Errata – January 22, 2021

Statewide Survey of Aquifer Suitability for Aquifer Storage and Recovery Projects or Aquifer Recharge Projects

Final Report

TWDB Contract No. 2000012405

Figure ES1. Final Suitability Rating for ASR

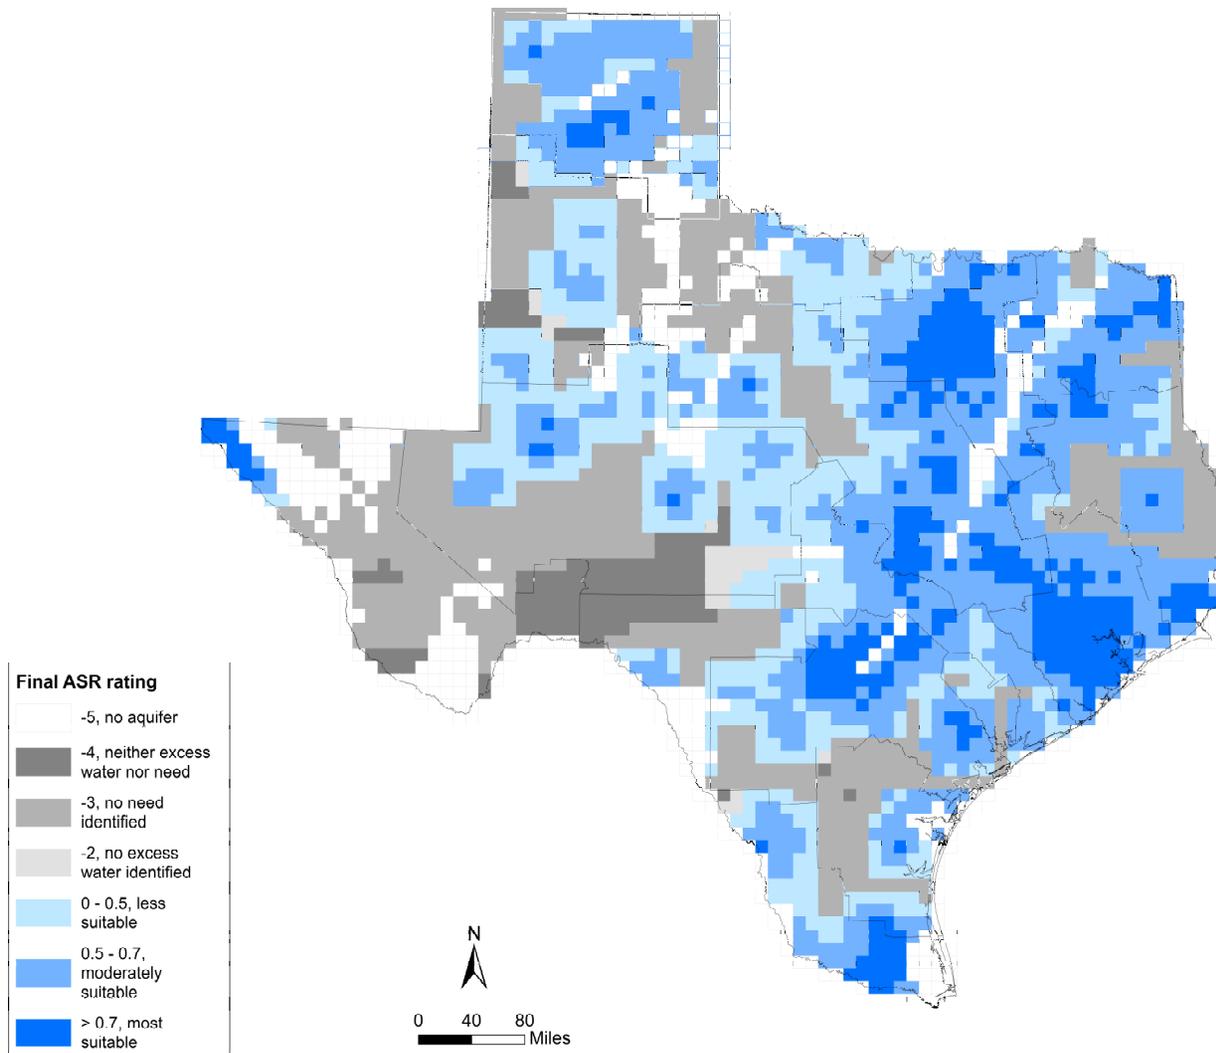
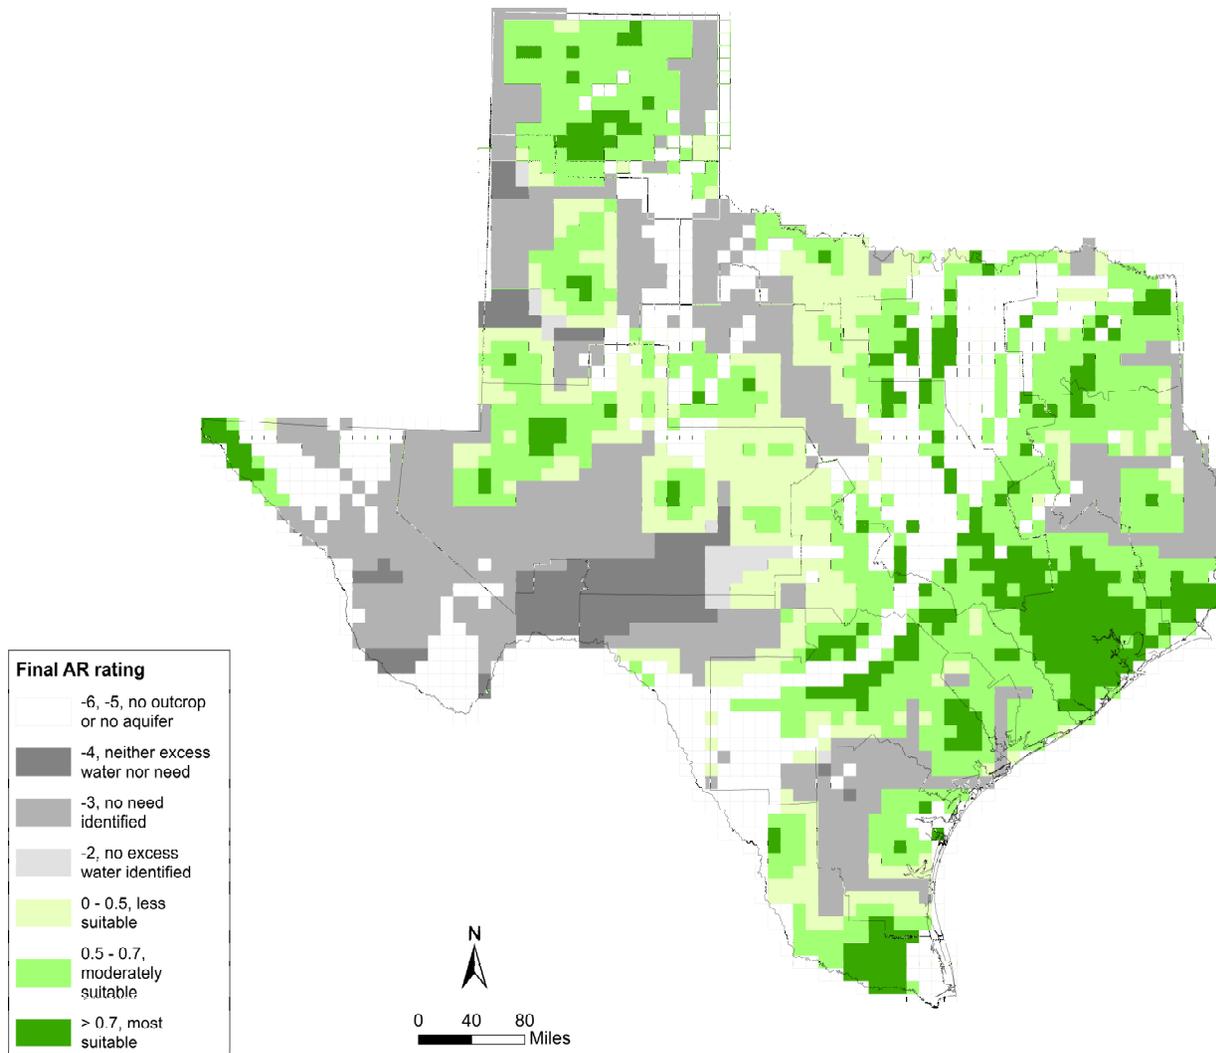
36. Page 3 and 4, Figures ES1 and ES2: Consider removing these maps so the executive summary focuses on the final suitability rating or adding the summation maps for excess water and water supply needs. *Response: Removed hydrogeological parameter screening maps for brevity in executive summary.*

Figure 3. Hydrogeological Parameter Screening Scores for ASR for Major and Minor Aquifers (maximum score)

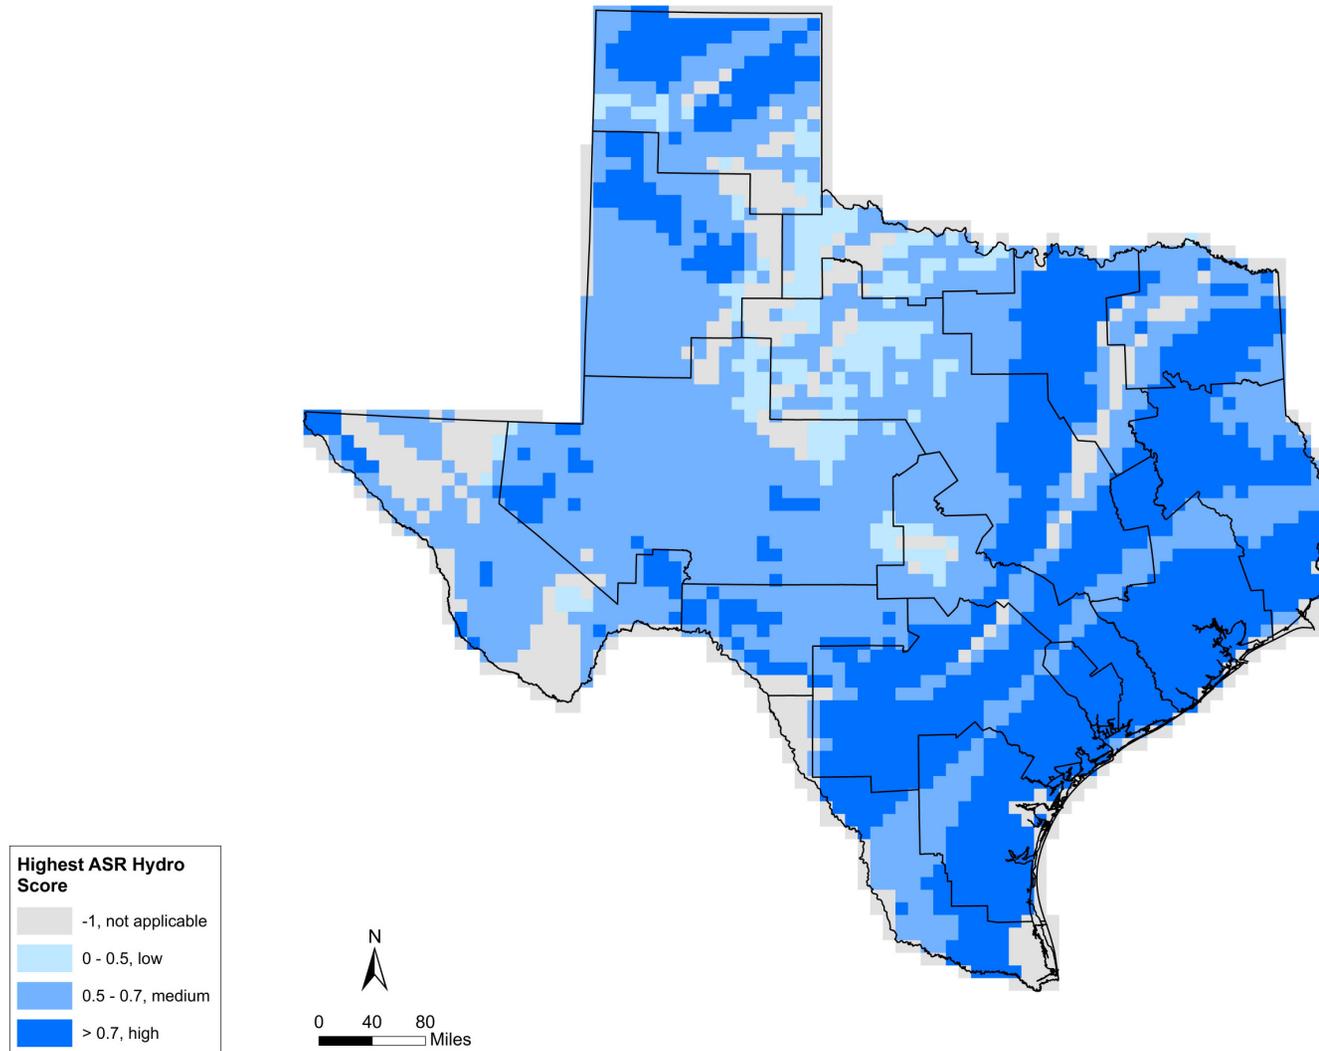
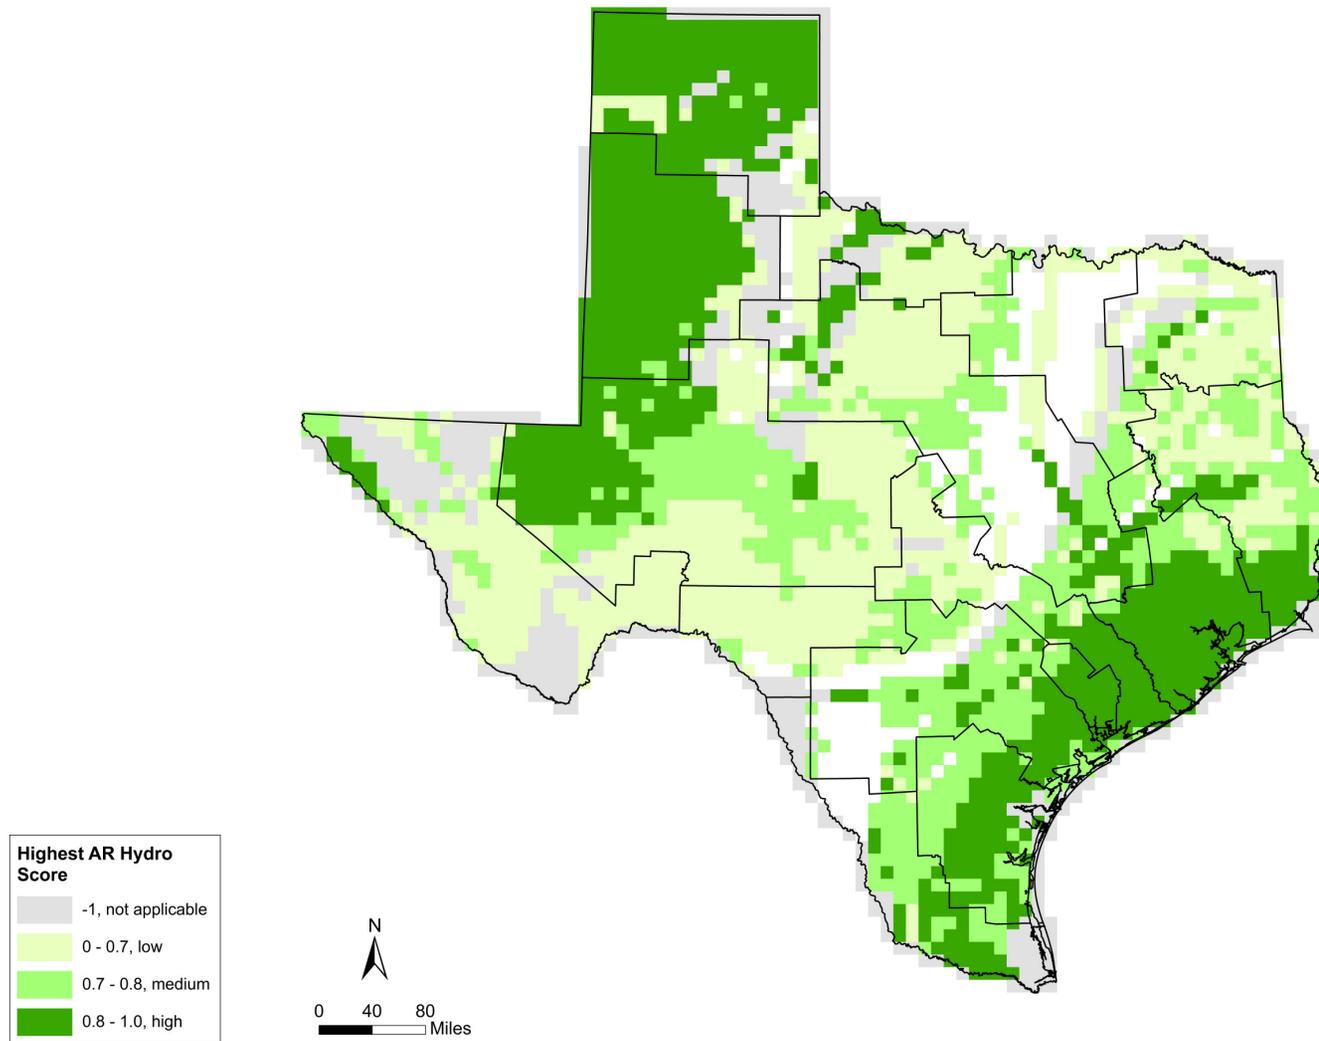
52. Figures 3 and 4: It was understood that the highest scoring aquifer was used for the final score for each grid cells with more than one aquifer. The only mention of using the highest aquifer suitability score for each grid cell is in the caption for Figures 3 & 4.
Response: Added in the results section.

Figure 5. Framework of Excess Water Screening

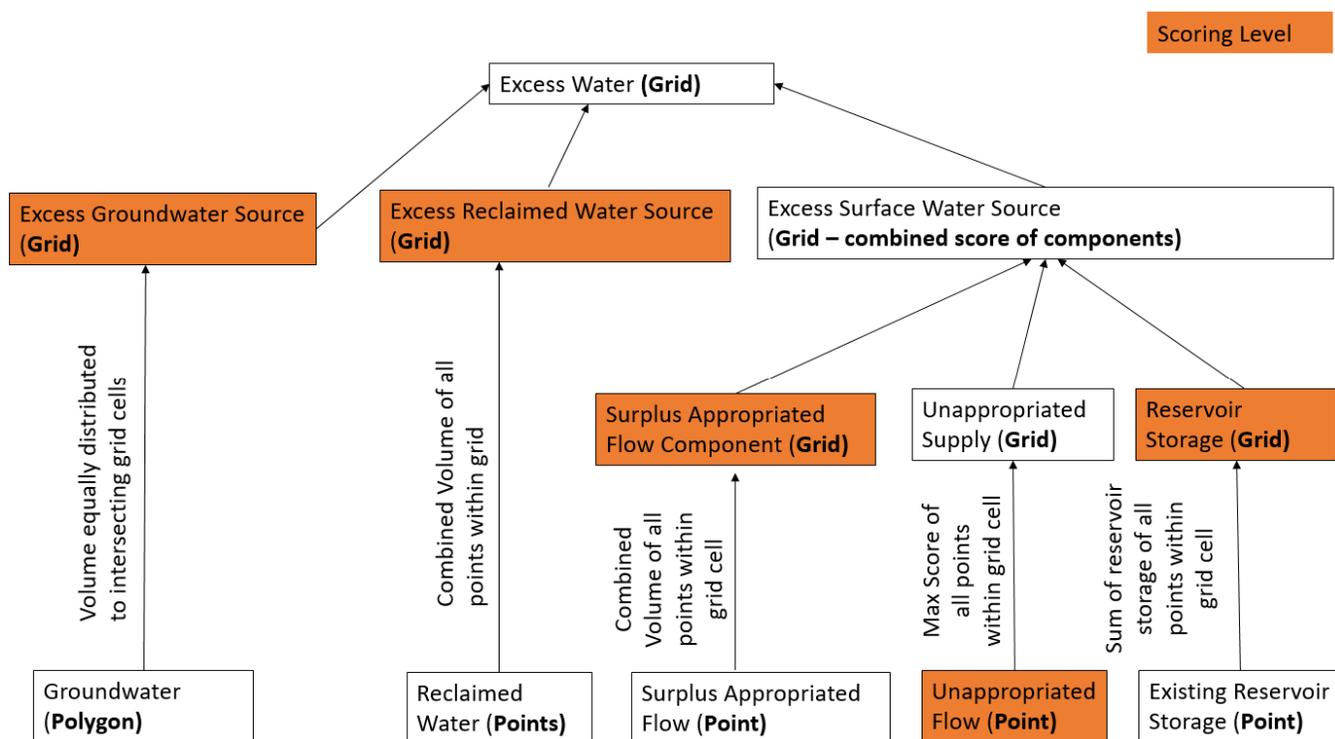
84. Page 42, Figure 5: In the figure caption, state that the orange highlights indicate the level at which availability of excess water sources is scored. *Response: Added note accordingly.*

Note: The orange highlights indicate the level at which availability of excess water sources is scored.

Figure 16. Water Supply Needs Screening Score Categories

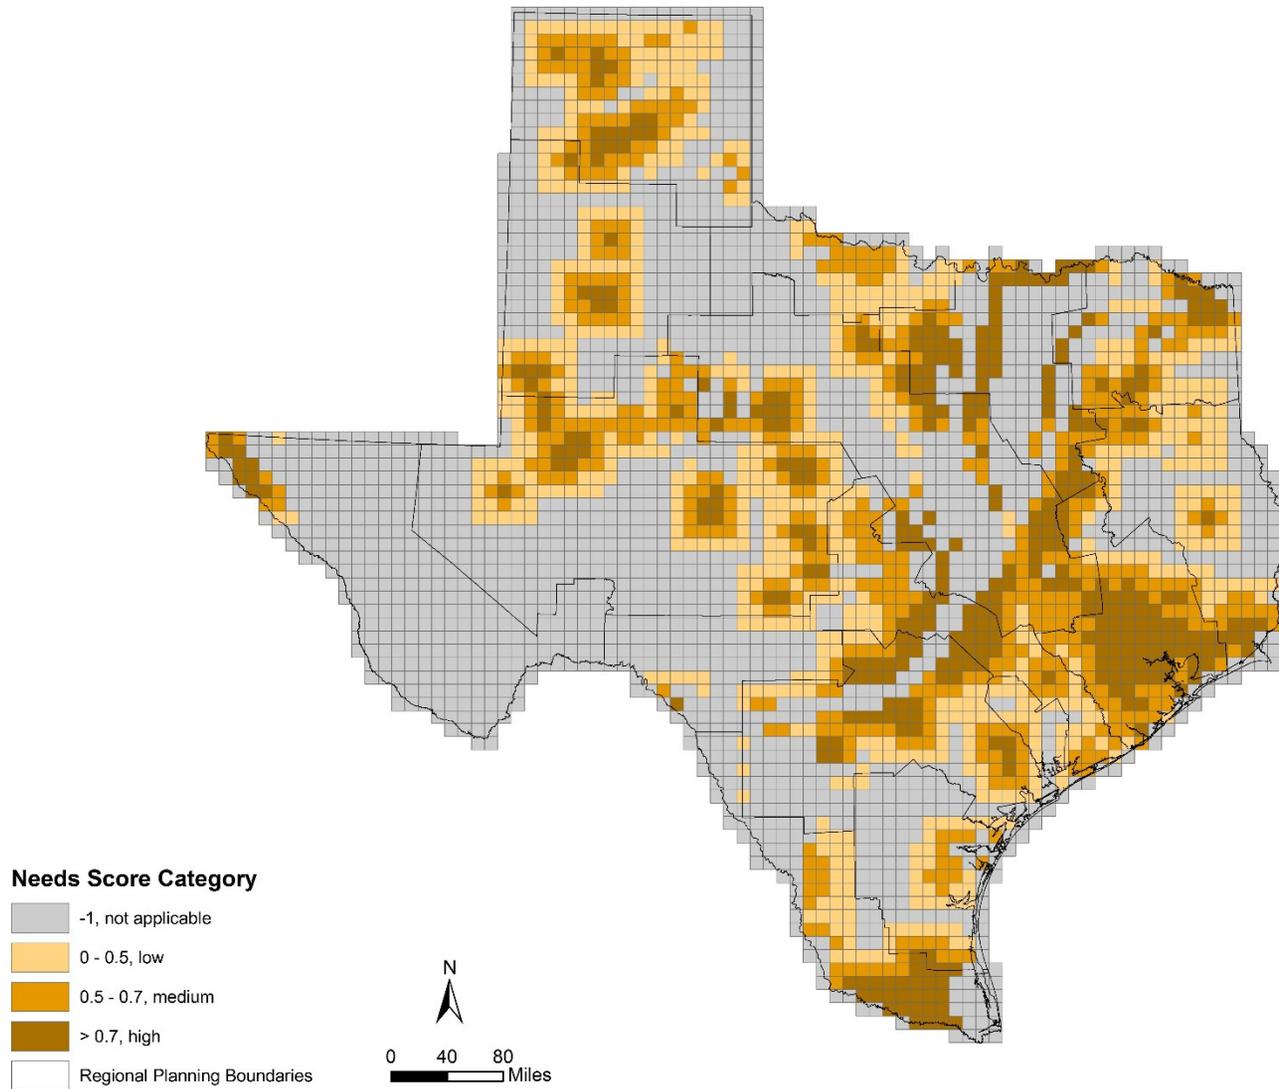
On pages 67, 73, 85, and 90, updates correct the threshold values used for excess water and water supply needs classified as “low,” “medium,” and “high” suitability as follows:

- Low– Water Supply Needs Score < 0.34
- Medium– Water Supply Needs Score 0.34 to 0.67
- High– Water Supply Needs Score > 0.67

Figure 19. Final Suitability Rating for ASR

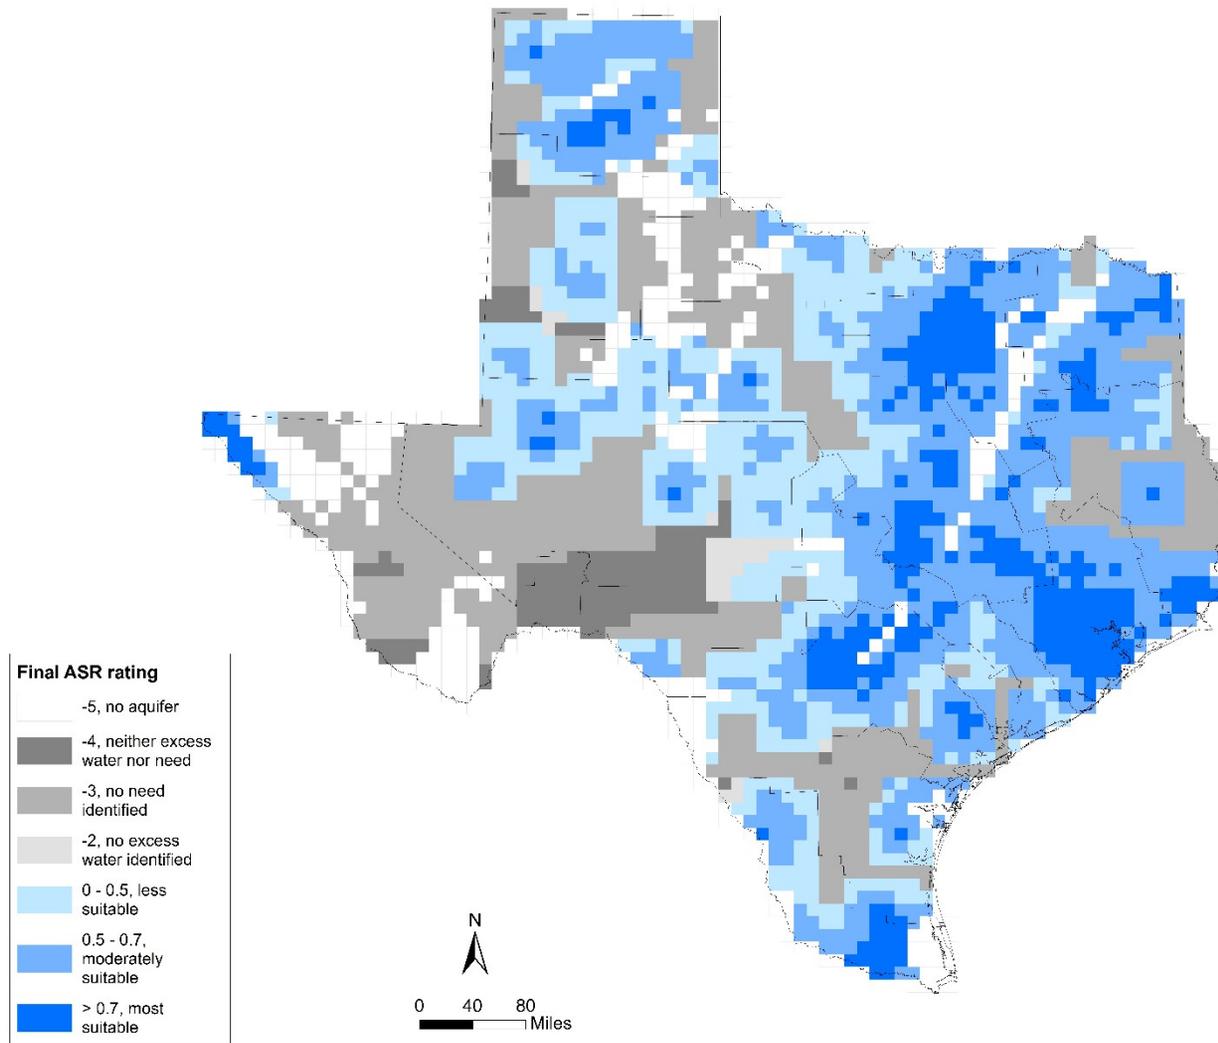
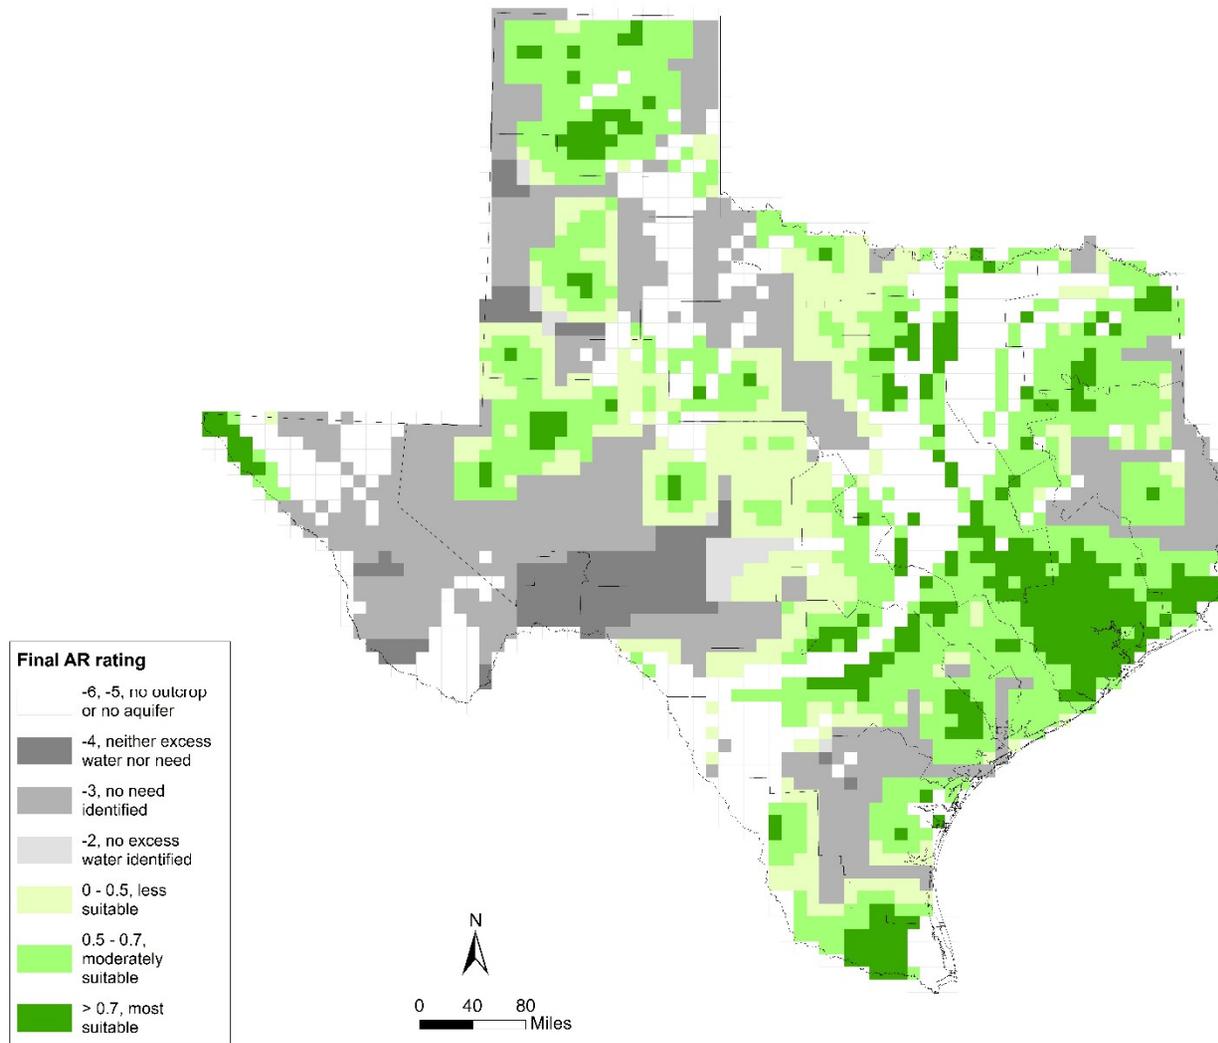
128. Page 85, 2nd paragraph: Consider discussing what made the top four aquifers so widespread and high scoring. *Response: Added discussion.*
129. Page 86-87, Figure 17 & 18, Make these maps shine! They are the big finale of the survey and should be the best maps in the report. *Response: Done.*
